Inspector Evaluation of
Beryllium Dorporation
Hazelton, Pennsylvania 18201
License Number 37-07676-01

SPECIAL LIMITED INSPECTION

Beryllium Corporation
Hazelton, Pennsylvania 18201

37-97676-01 ---- Amend. No. 05, issued 9/8/67 --- E (2)IV

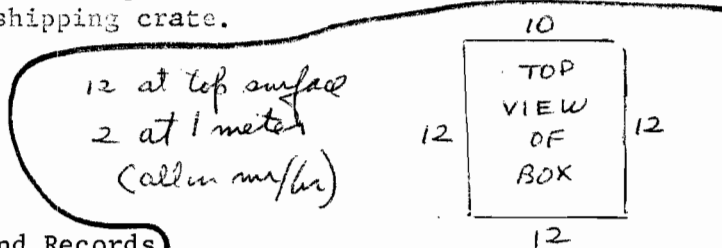
Routine direct reading surveys on monthly basis. Also, always survey around shipping crate before shipping unit for source replacement. See diagram for typical results --- (readings are for current unit when received -- put in use 8/4/69):
ALSO SEE EXHIBIT A FOR ROUTINE SURVEY RESULTS.
